## CALIFORNIA COASTAL COMMISSION

REGULAR CALENDAR  
STAFF REPORT AND PRELIMINARY RECOMMENDATION

Application No.: 6-02-119

Description: Follow-up to emergency permit (#6-97-144-G) to repair existing rip rap revetment to include the addition of approximately 20 tons of new stones, realignment of public access path across the revetment, and after-the-fact approval to construct a 750 sq. ft. restaurant addition, a 420 sq. ft. upper story balcony dining area and a 1,172 sq. ft. outdoor patio dining area on an approximately 35,284 sq. ft. lot containing an approximately 7,287 sq. ft. restaurant.

California Coastal Commission	EXHIBIT NO. 4
	APPLICATION NO.
	6-02-119

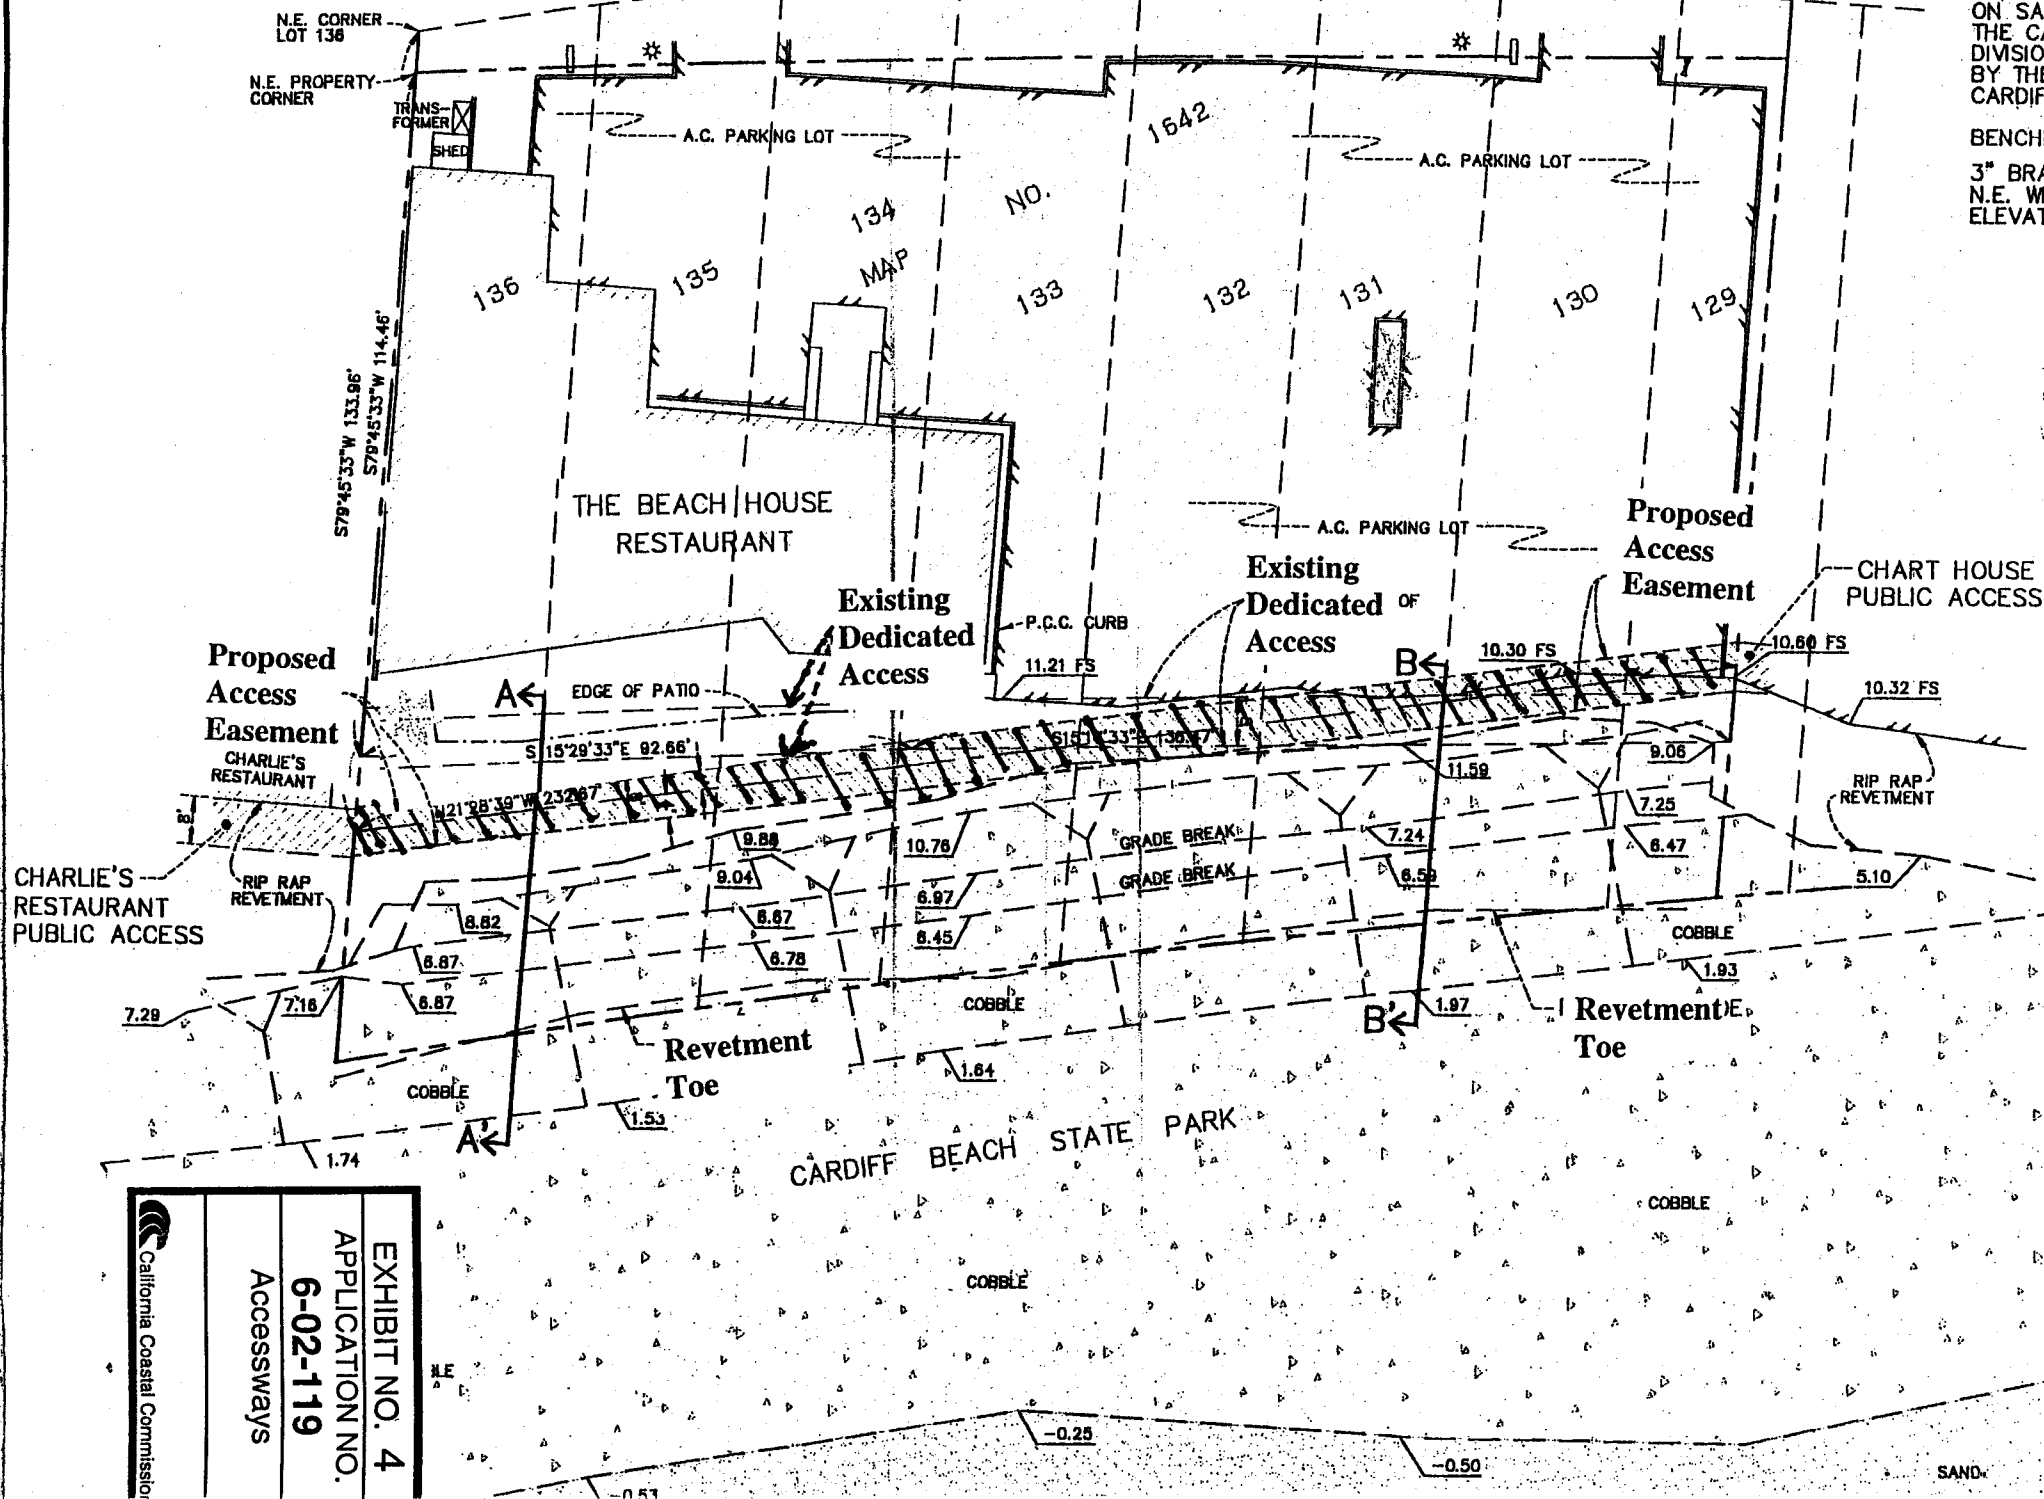
**B. PRIOR TO ISSUANCE BY THE EXECUTIVE DIRECTOR OF THE NOI FOR THIS PERMIT**, the applicant shall submit for the review and approval of the Executive Director, and upon such approval, for attachment as an Exhibit to the NOI, a formal legal description and graphic depiction of the portion of the subject property affected by this condition, as generally described above and shown on Exhibit #4 attached to this staff report.

Detail of North End of  
Accessways

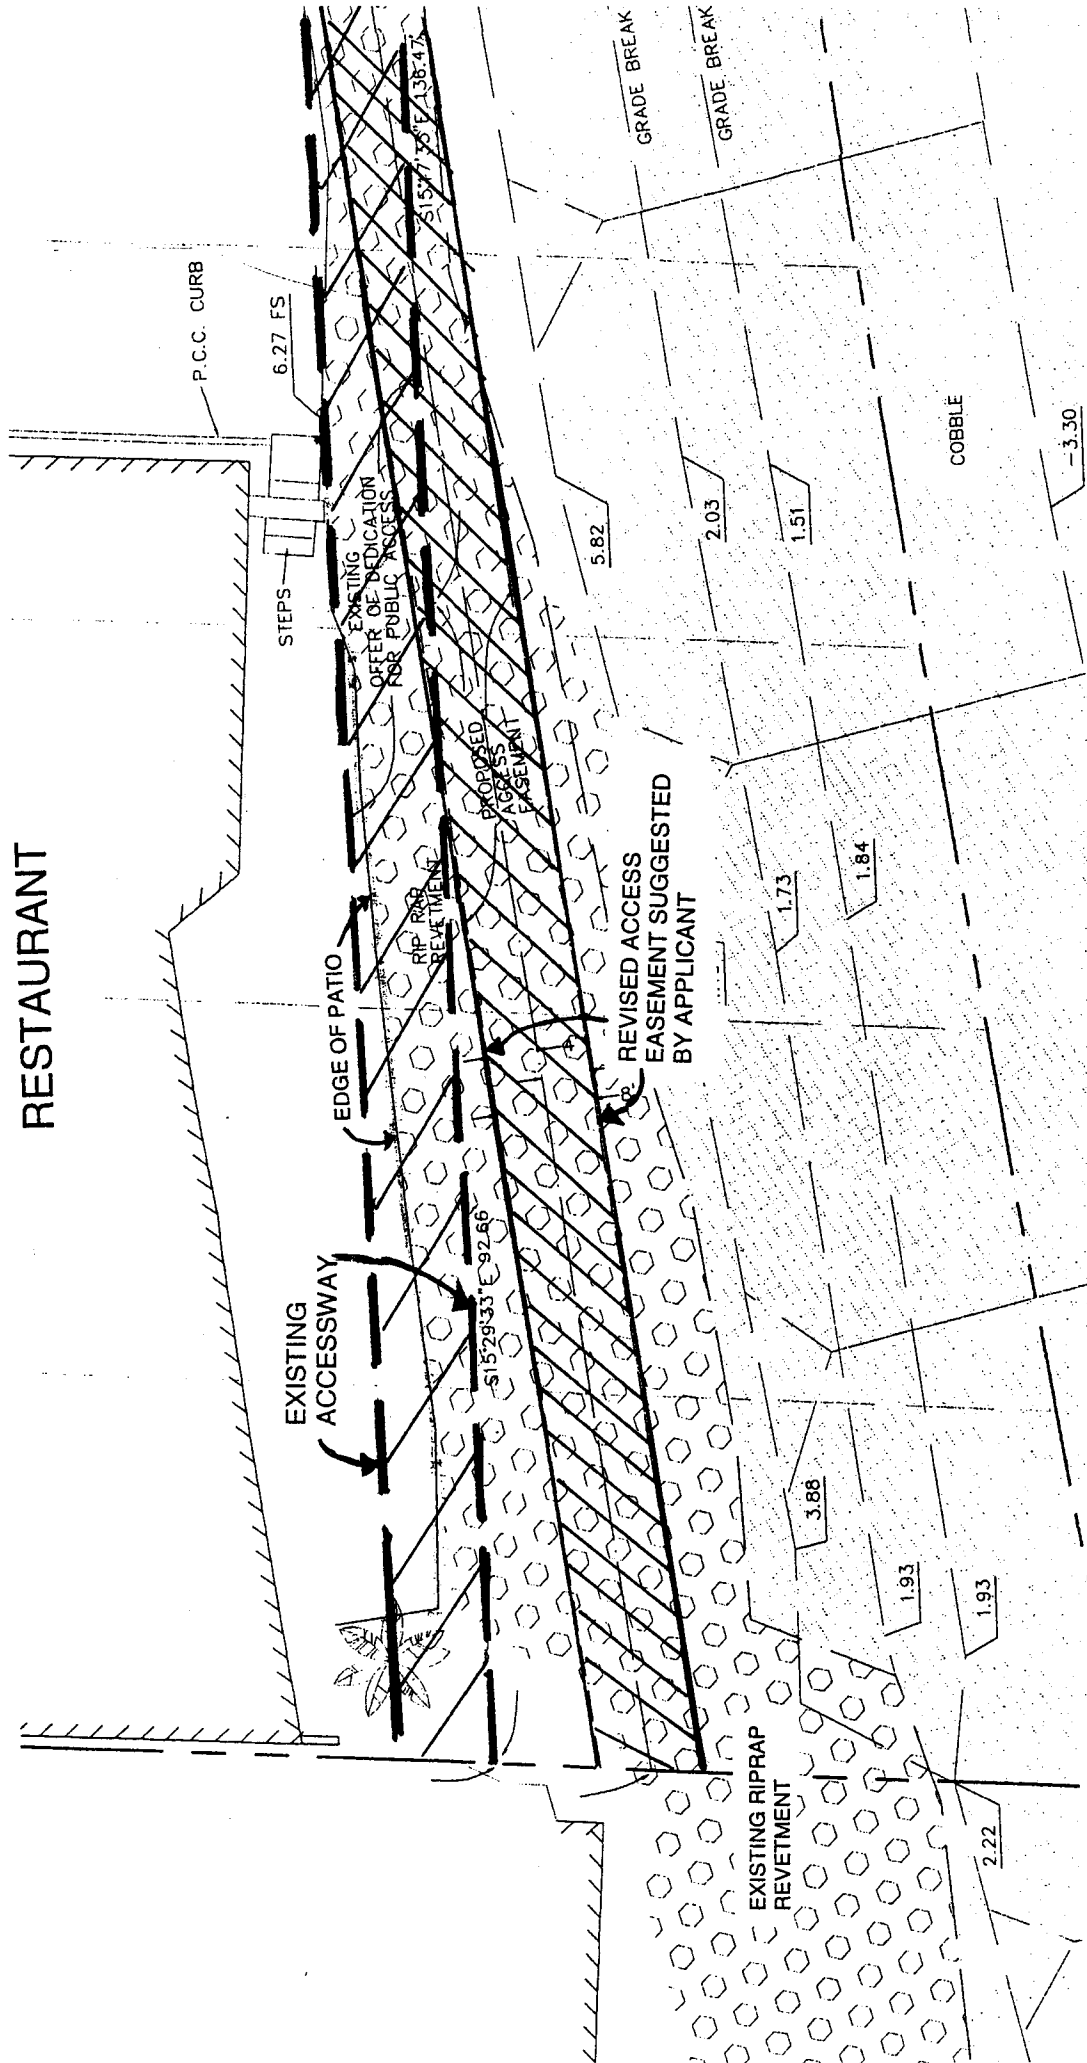
The subject property is currently developed with a two-story restaurant, a paved parking lot, landscaped areas and a riprap revetment. The original Commission action on the subject site approved construction of the restaurant in a location that would allow an 8 ft.-wide public accessway to be provided between the restaurant and the revetment. However, although the restaurant appears to be sited in its approved location, the current plans and on-site conditions show that the existing riprap revetment, proposed herein for after-the-fact maintenance and augmentation, and a portion of the dining patio, which is also proposed for after-the-fact approval, are located within the dedicated public accessway, thereby precluding improvement of the walkway and the potential for the public to use the area. (see Exhibit #5).

EXHIBIT NO. 7  
APPLICATION NO.  
**6-02-119**  
Realigned  
Accessway Concept

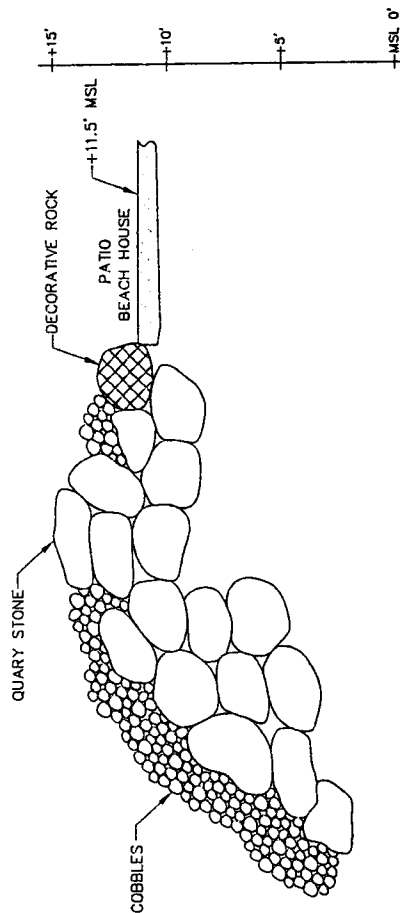
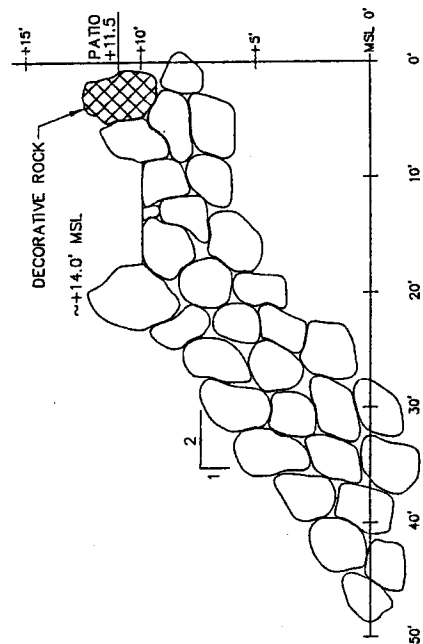
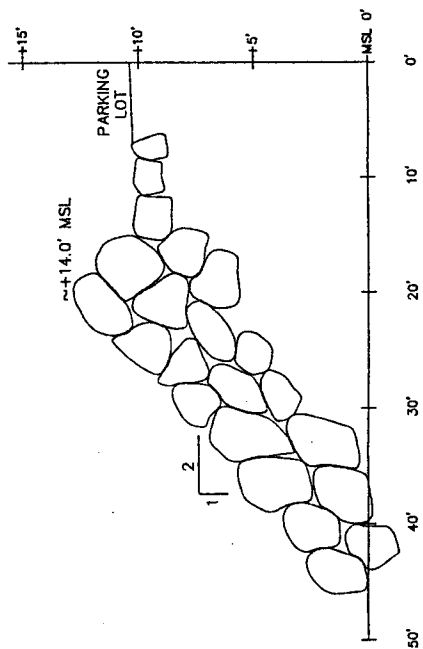
The Commission's engineer has reviewed the proposed walkway design and has identified safety and visual concerns with the proposed elevation of the walkway. As proposed, the walkway is approximately 1 ½ ft. lower than the neighboring restaurant patio with, in some places, a large approximately 4 ft.-high rip rap stone on its seaward side. The safety concern is that the large stone may become dislodged onto the path and the visual concern is that small children may not be able to see over the stone. Special Condition #1d requires the applicant to revise the project to increase the height of the walkway to at least the same elevation of the neighboring patio which is approximately 11.5 ft. above Mean Sea Level (MSL). By elevating the path, the revetment will be more stable, safe and usable. Additionally, public views toward the ocean from the pathway must be maintained.

- a. The proposed revetment has been engineered such that the encroachment onto the beach is the minimum necessary to protect the structure, and that all riprap that has migrated beyond the toe of the revetment has been removed or incorporated into the revetment. In no case shall the repaired revetment encroach further seaward than the existing revetment, as shown on Exhibit #4.
- b. The access path shall be permeable so as to permit runoff to filter through the path.
- c. The access path shall contain a level surface so as to facilitate public access.
- d. The elevation of the access path shall be revised to be at or above the grade of the adjacent outdoor dining patio (approximately 11.5 ft. above Mean Sea Level (MSL)) so as to maximize views of the ocean by users of the path.
